AMENDMENT 005

ADDENDUM #1

Project title/Titre du projet
**AGASSIZ, BC
KENT MAXIMUM SECURITY
INSTITUTION**

**MECHANICAL SYSTEM
UPGRADE FOR CELL BLOCKS
A through H and J & K**

M4-01

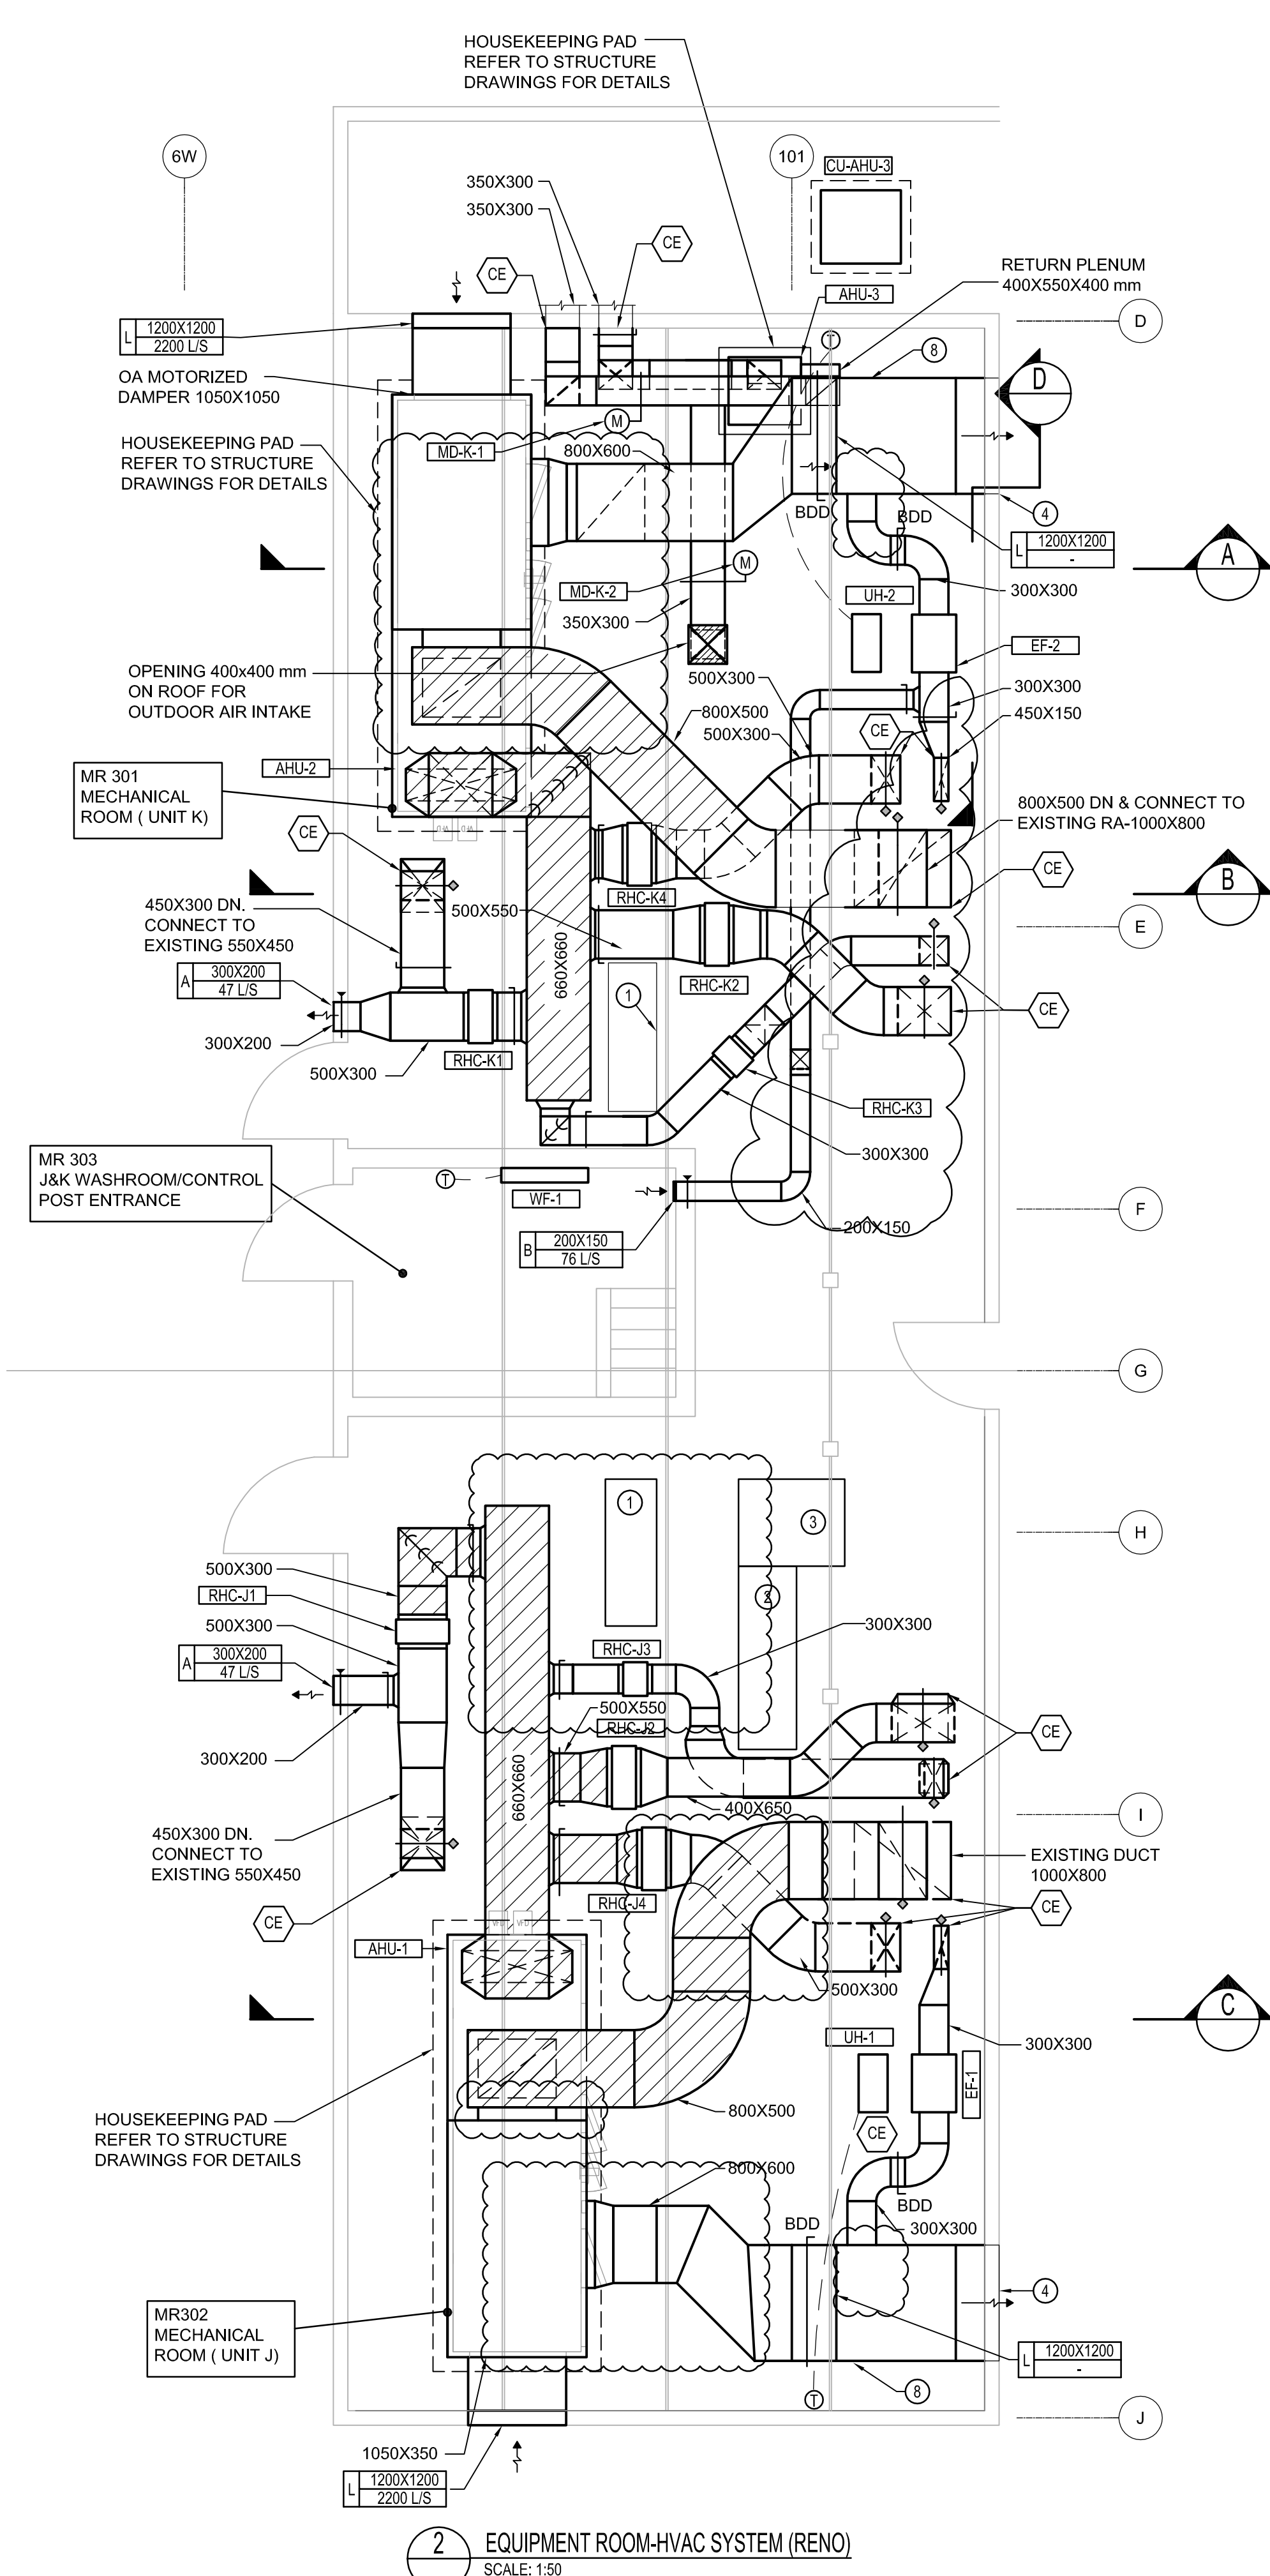
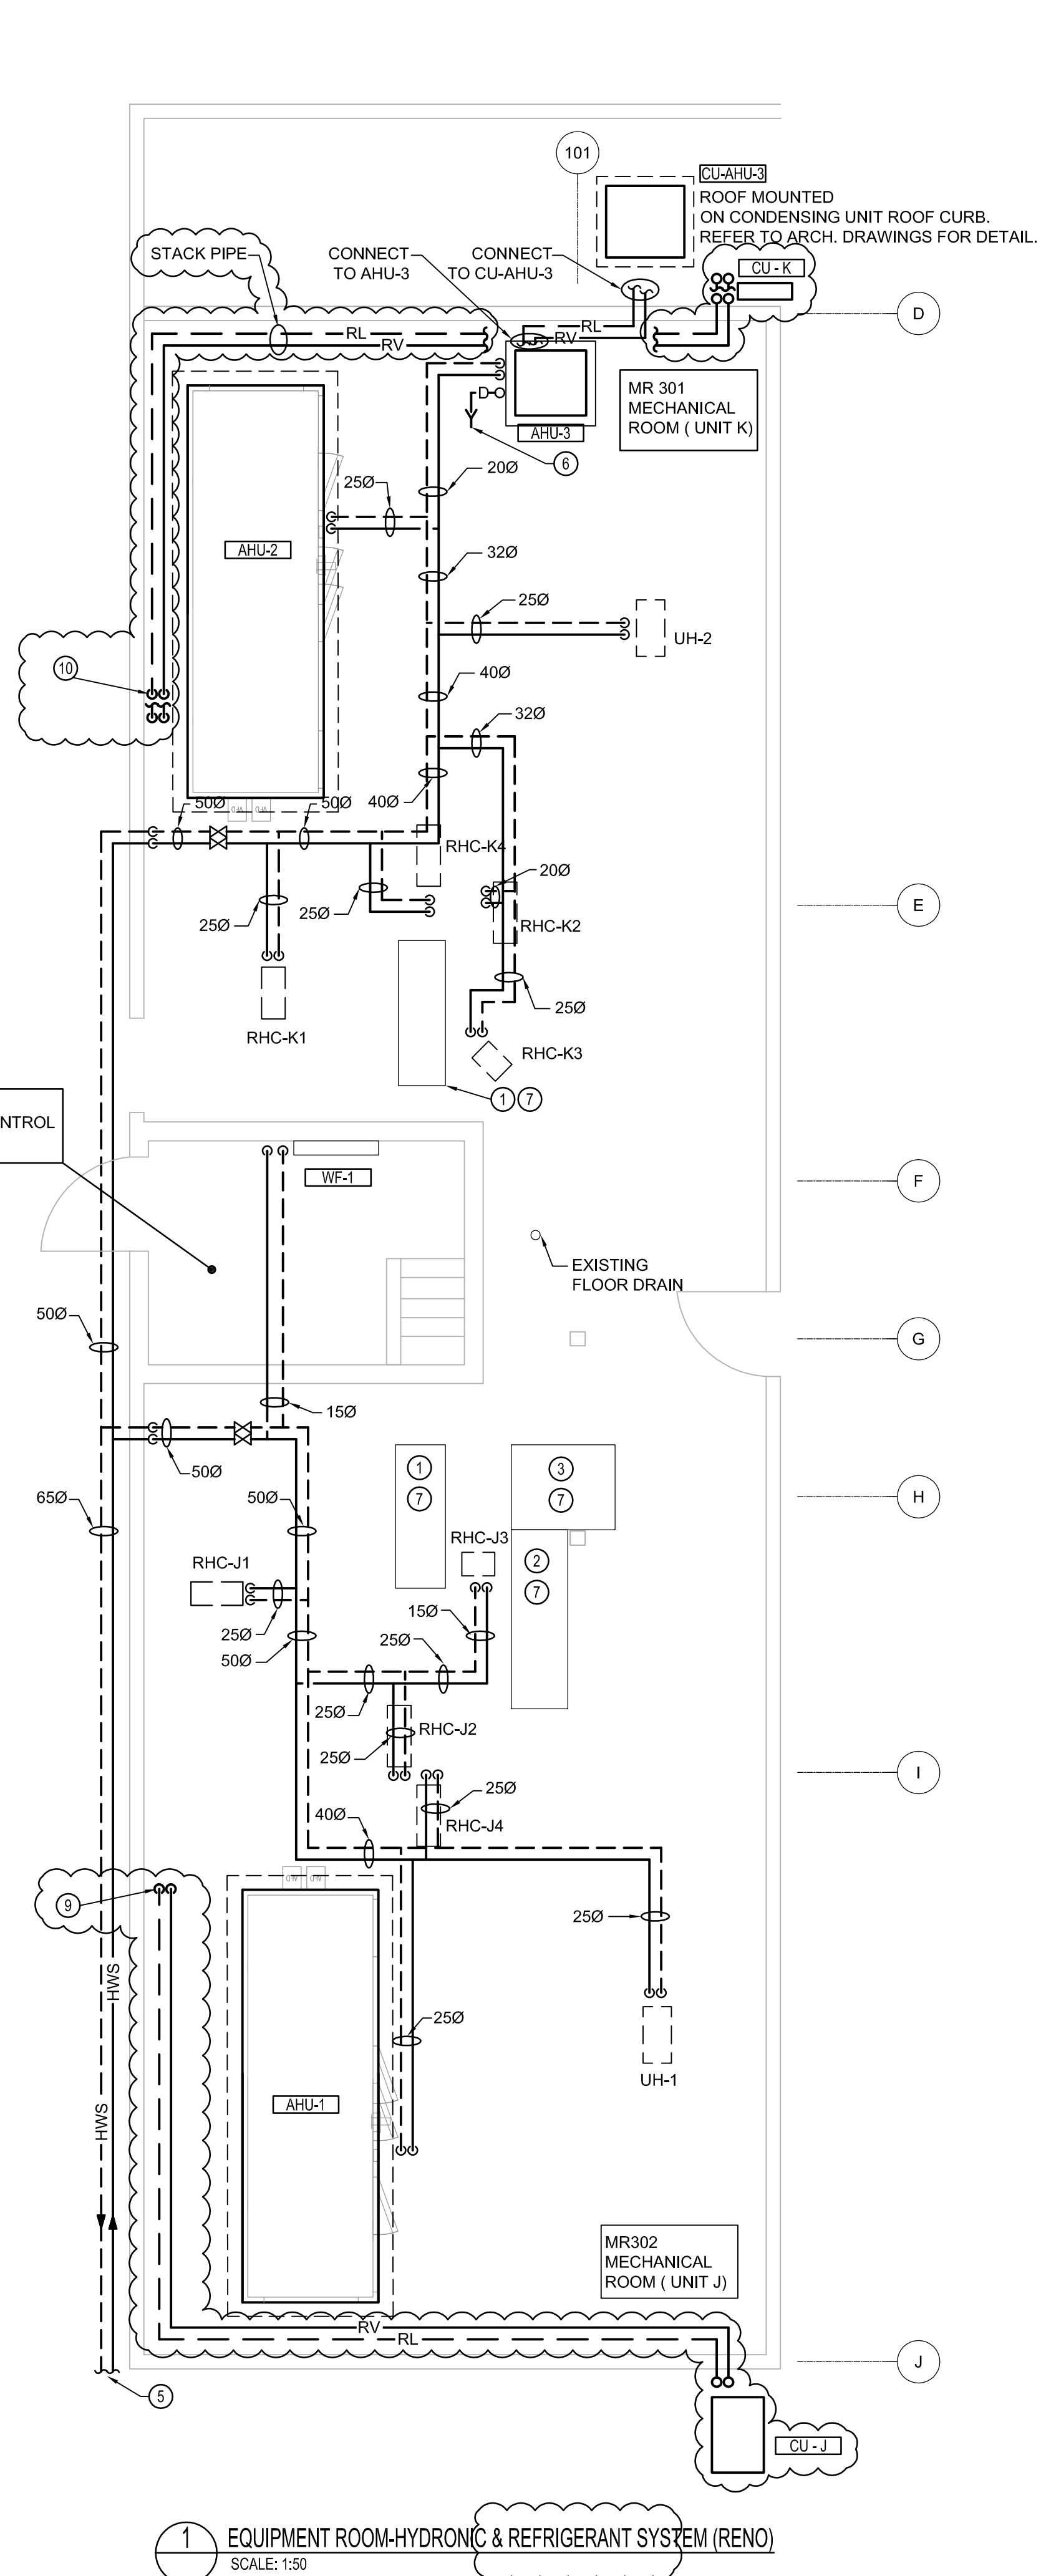
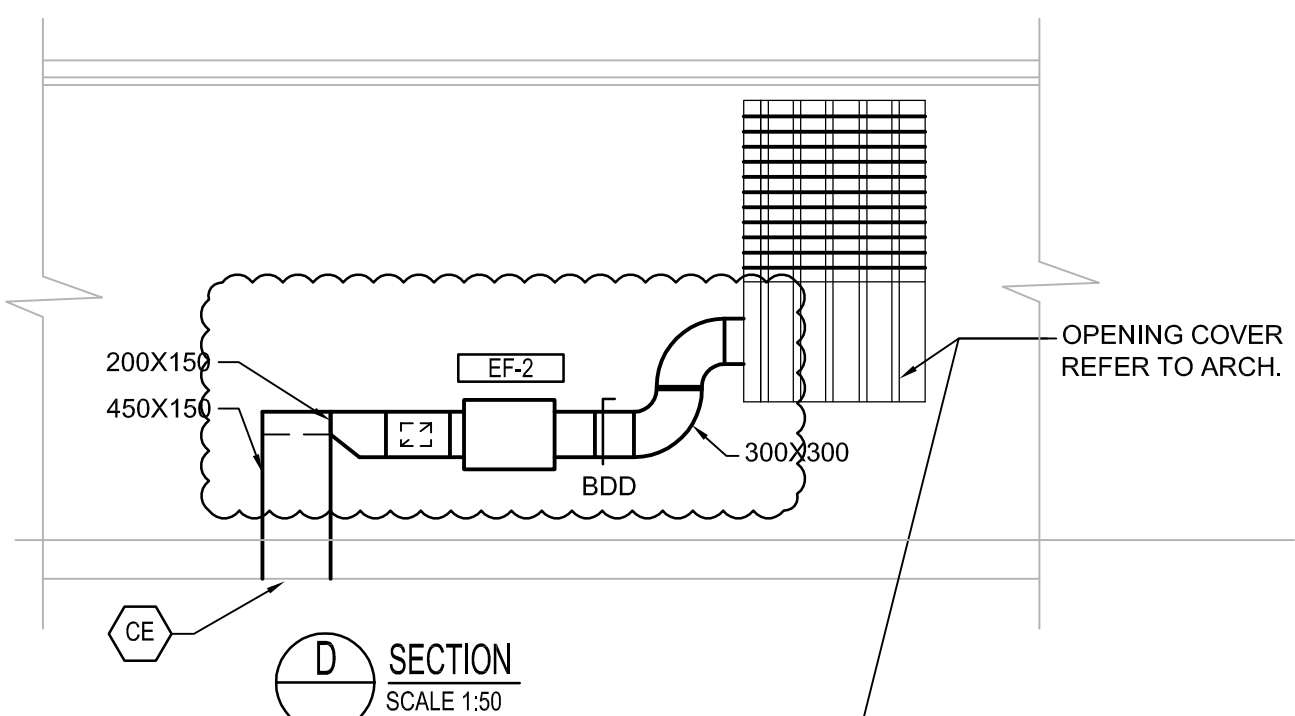
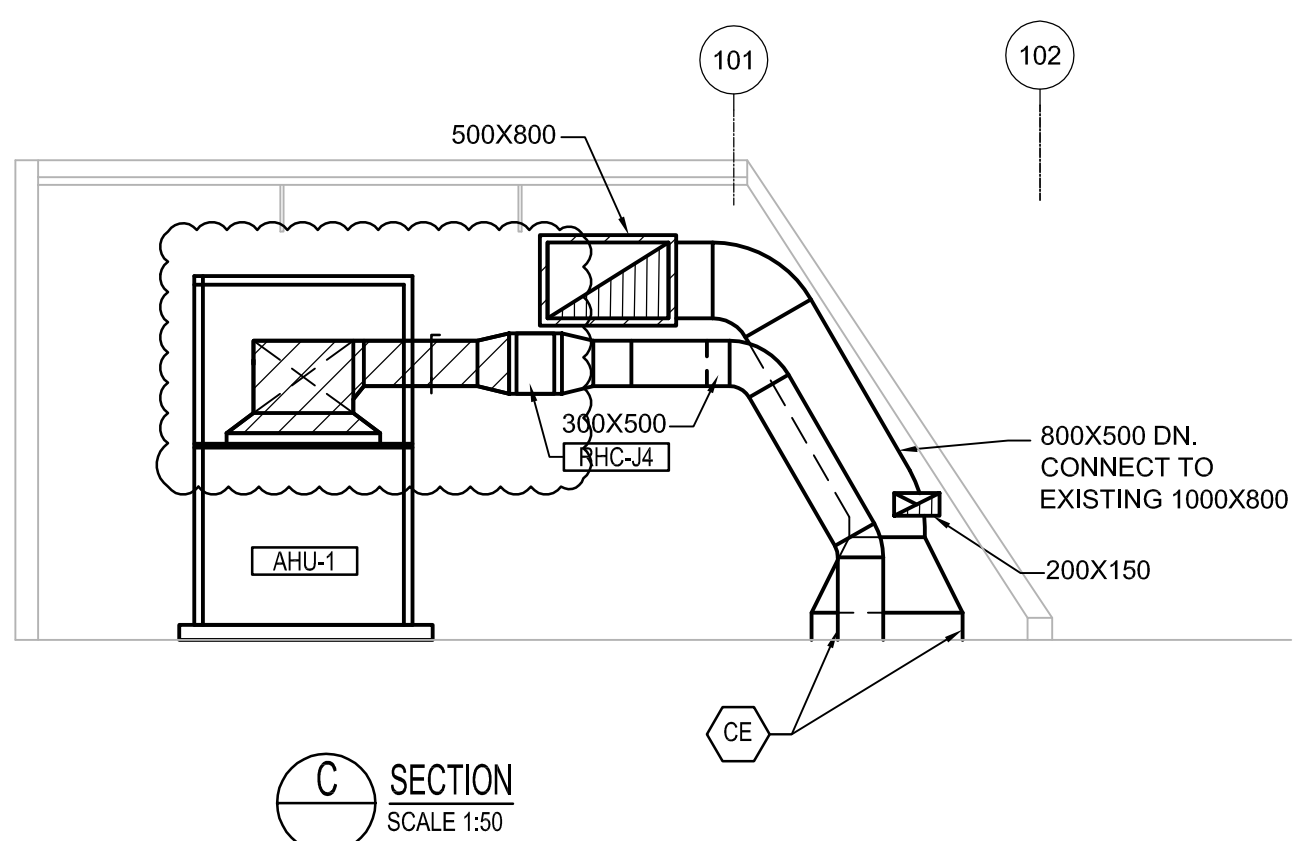
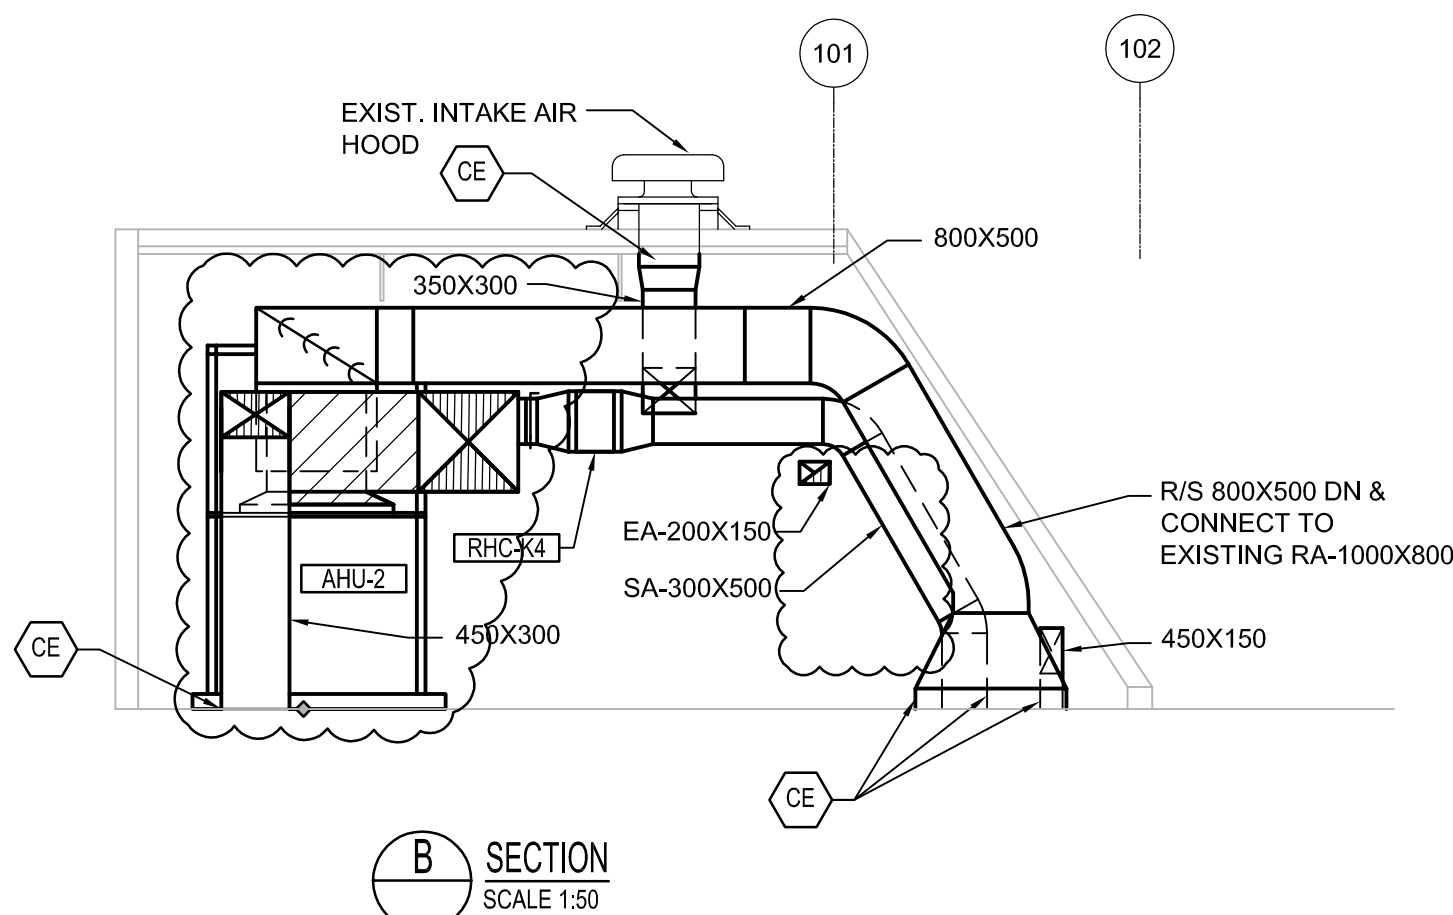
1. Refer to Tender Mechanical Drawings M4-01:

1. Revise mechanical equipment room (J&K) HVAC system as shown clouded on the details No. 2, A, B, C and D of the attached drawing

- (2) Provide new refrigeration piping complete with insulation.
 - (3) Run new refrigerant piping up to mechanical rooms J and K, and from mechanical rooms to the roof as shown on the detail No. 1 on the attached drawing M4-01. Allow for approximately a total of 150 meter for each refrigerant Liquid Line and Suction Line.
